## **HISTORIC SITE PRESERVATION BOARD STAFF REPORT**

SUBJECT: A REQUEST BY THE MEZRAHI TRUST FOR APPROVAL OF A CERTIFICATE OF APPROPRIATENESS - MAJOR FOR ALTERATIONS TO "THE GAS COMPANY BUILDING", A CLASS 1 HISTORIC SITE LOCATED AT 211 NORTH SUNRISE WAY; HSPB #158. (APN 508-070-016). (SY).

## Response Letter to HSBP Comments

SHEET NAME: Demolition and Removal - Roof Plan

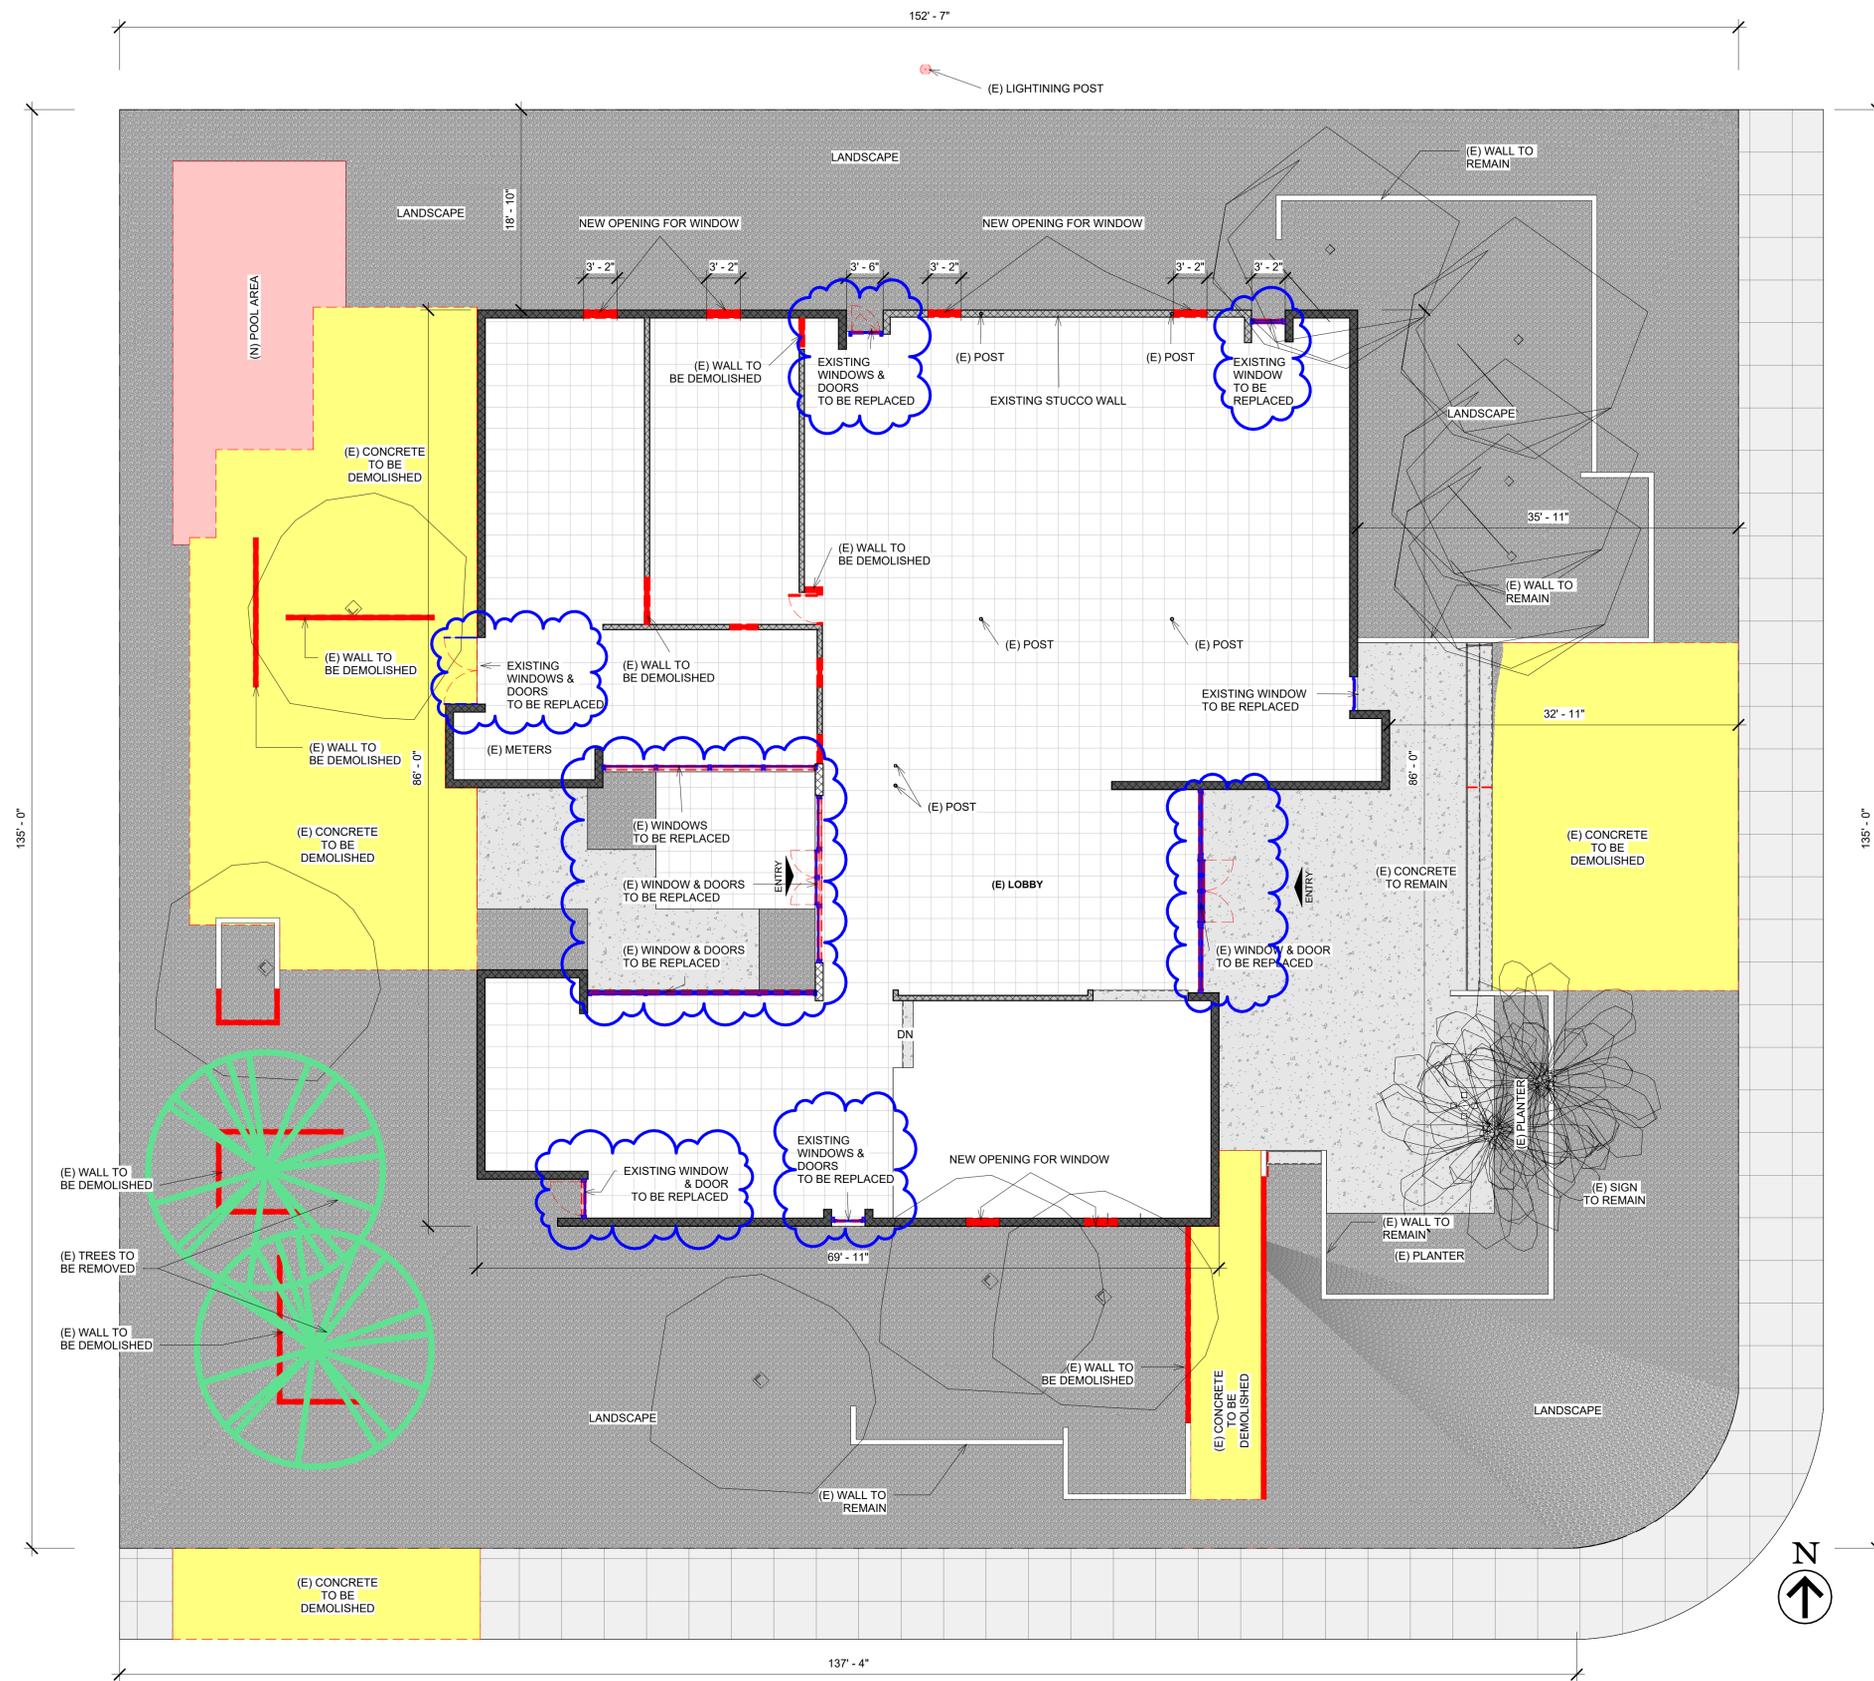
- **Planter/landscape conditions (existing and proposed) on the west elevation:**  
We propose functional additions, including the garage, exterior kitchen, and pool. The secondary planter walls to be removed are constructed with concrete blocks and paint, and they do not hold the same architectural significance as the poured-on-site concrete walls of the main facades. Details of these removals are indicated in **A1.11-Demolition and Removal Floor Plan**.
- **Call out of landscape walls that are proposed to be removed:**  
All proposed removals are detailed in **Sheet A1.10 - Demolition and Removal Floor Plan**.

SHEET NAME: Proposal - Floor Plan

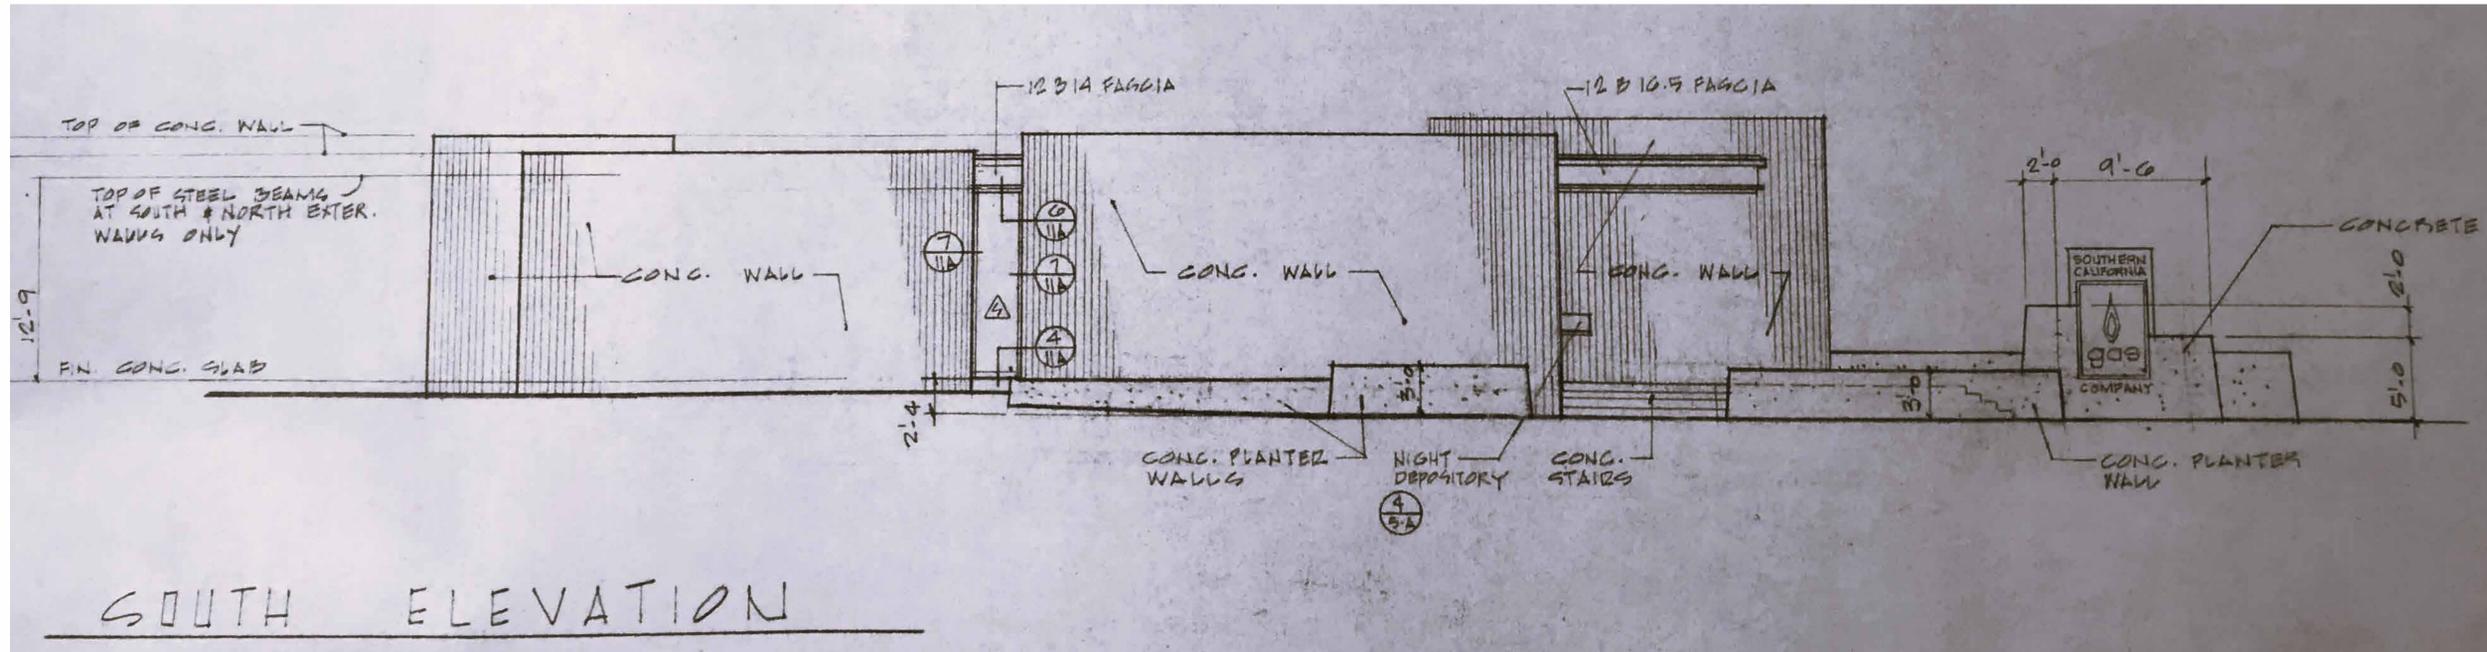
- **Have you considered possibly flipping the location of the outdoor dining area and the pool? The outdoor dining area seems a bit far away from the kitchen.**

We revisited this idea and found that relocating the outdoor dining area closer to the kitchen improved both functionality and spatial efficiency. The updated floor plan reflecting this adjustment is now available on **A1.21 - Proposal - Floor Plan**.

SHEET NAME: Proposal - Garage Elevations

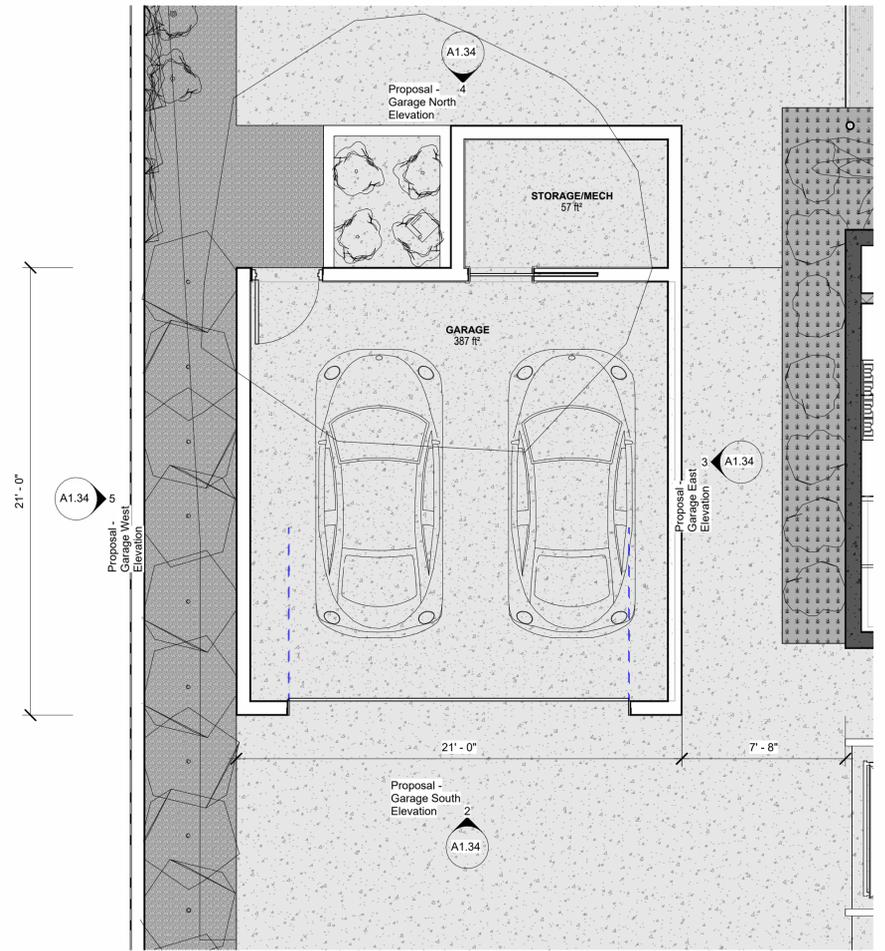
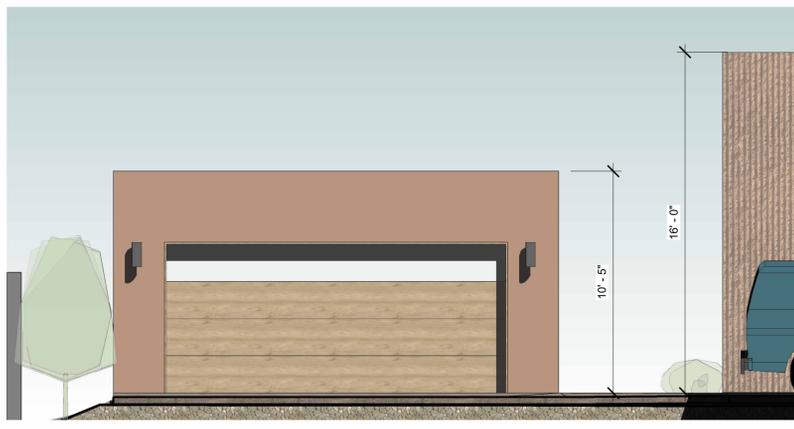
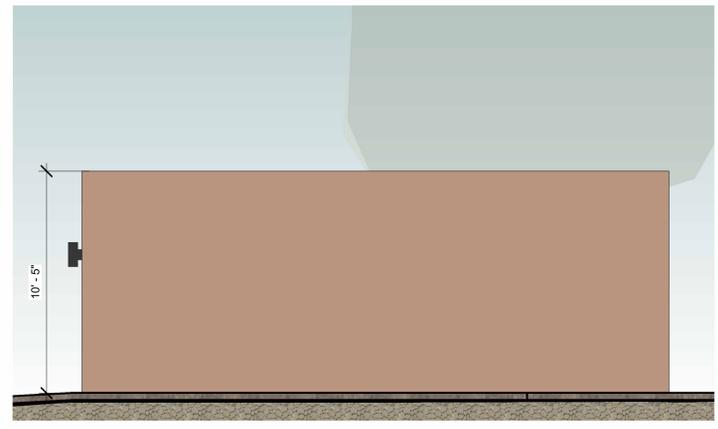
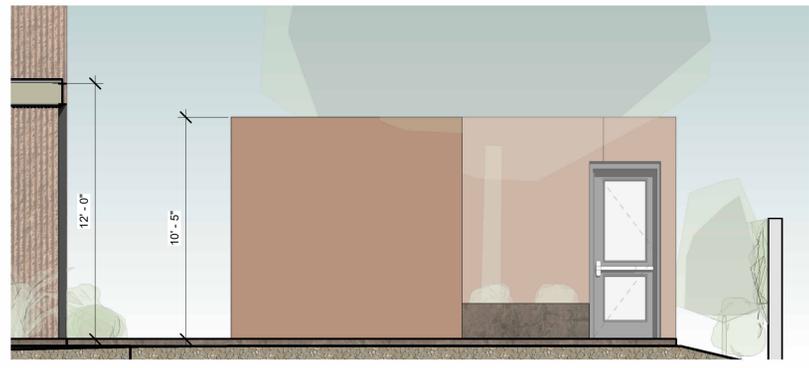
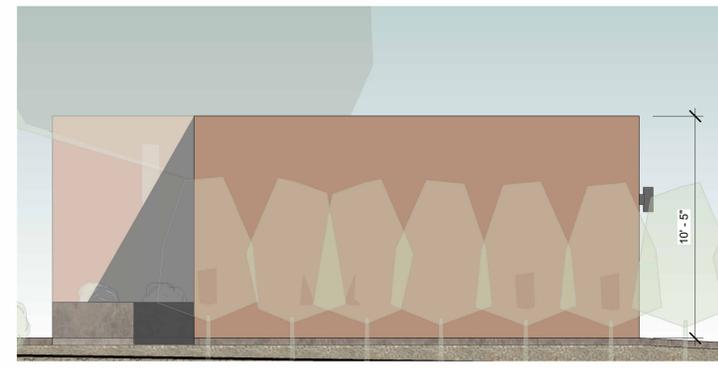
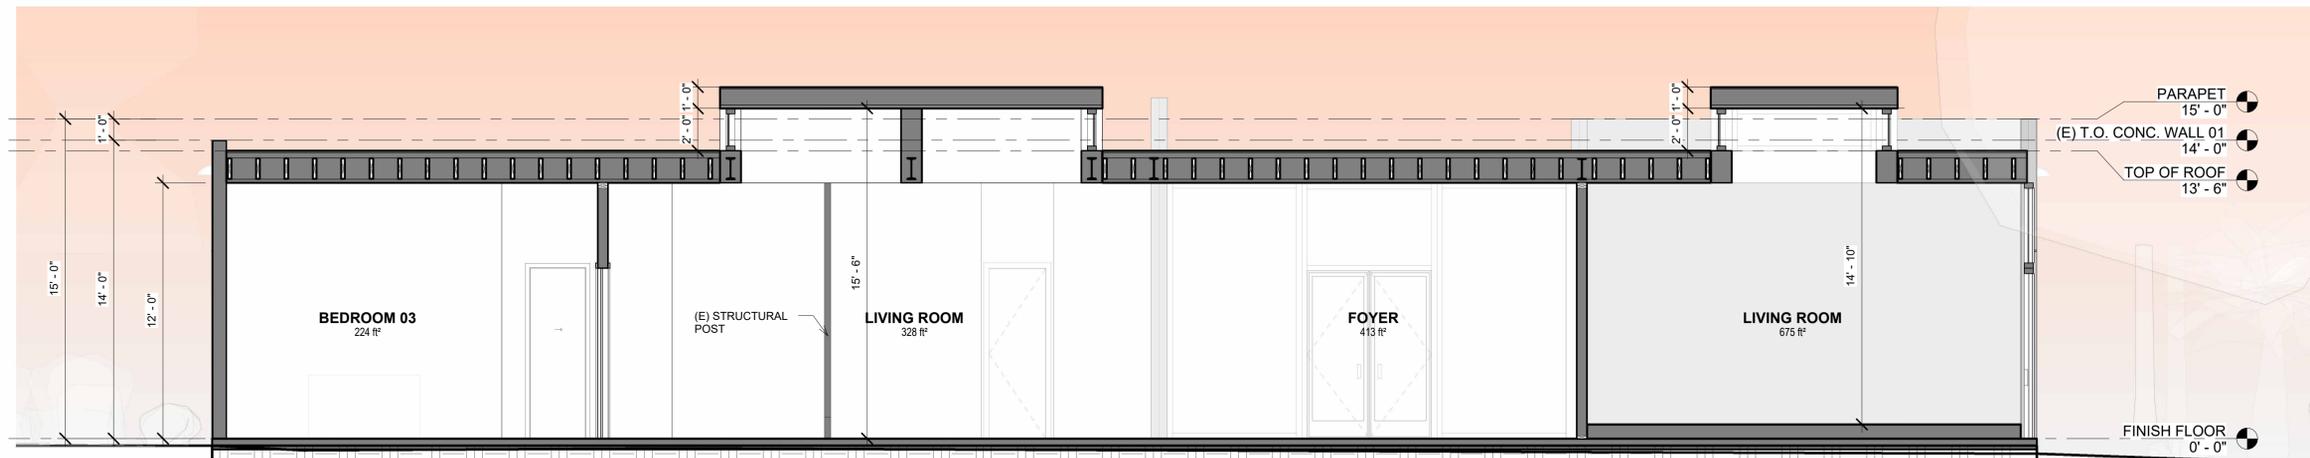
- **Clarify if existing (historic) openings will remain in the same location and size:**  
All historic openings will remain in their original location and size. Window replacements will match the original sizes and modulation, maintaining the building's design integrity.
  - **Provide elevations and material details for the proposed detached garage structure, garage door:**  
Detailed elevations and material specifications for the detached garage and garage door are included in **Sheet A1.34 - Proposal - Garage Elevations.**
-

DRAWN BY: MER  
CHECKED BY: VB  
DATE: 01/28/2025  
SCALE: As indicated  
JOB NO: 1719  
SHEET NAME: Proposal - Window and Door Schedule  
SHEET: A1.50

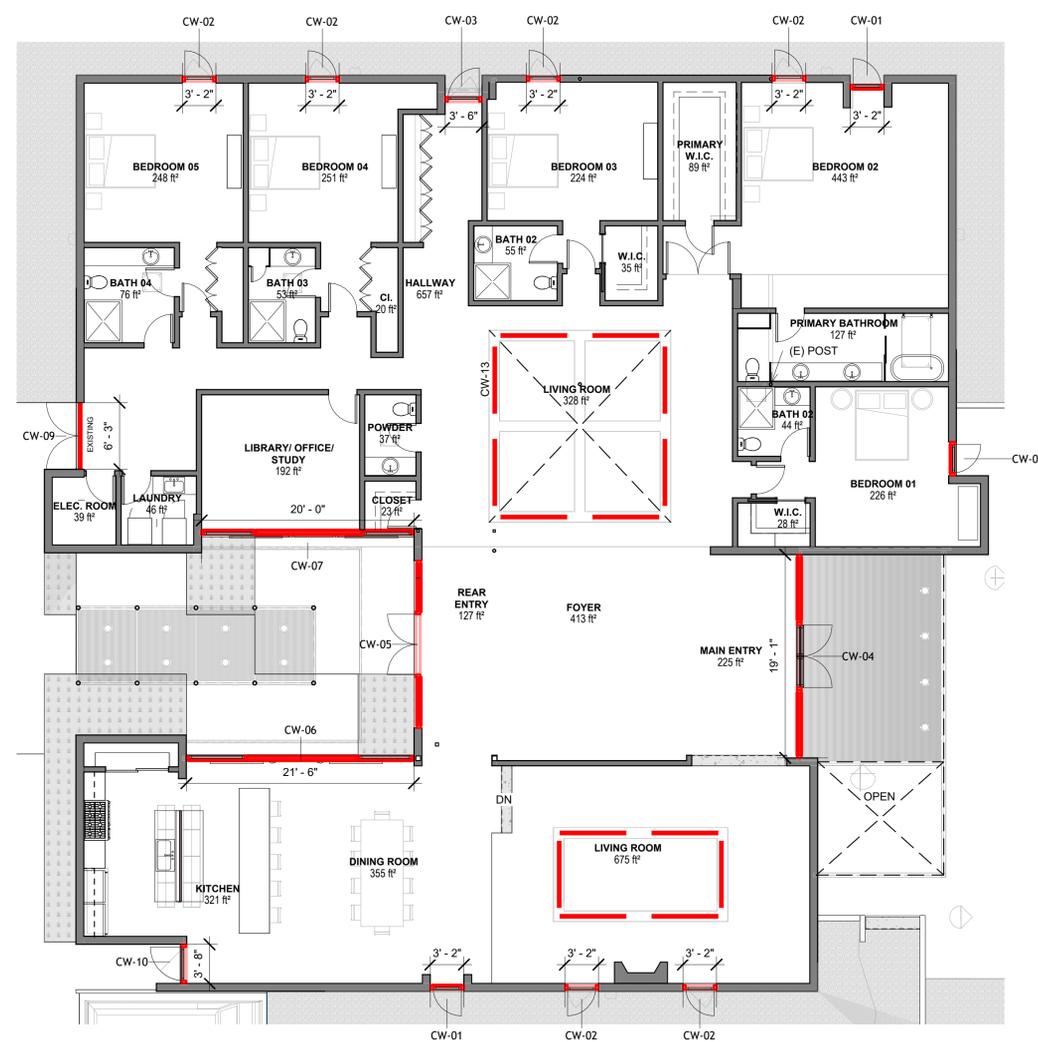
- **Identify openings that are required by building code requirements to see if the historic building code exception may be applied to protect historic fabric/materials by adjusting the location and possibly the size of the required openings:**

We have calculated the required openings for lighting and ventilation per the California Historical Building Code (CHBC) and included the updated window schedule in our architectural packet. This ensures compliance while protecting the historic fabric and materials.
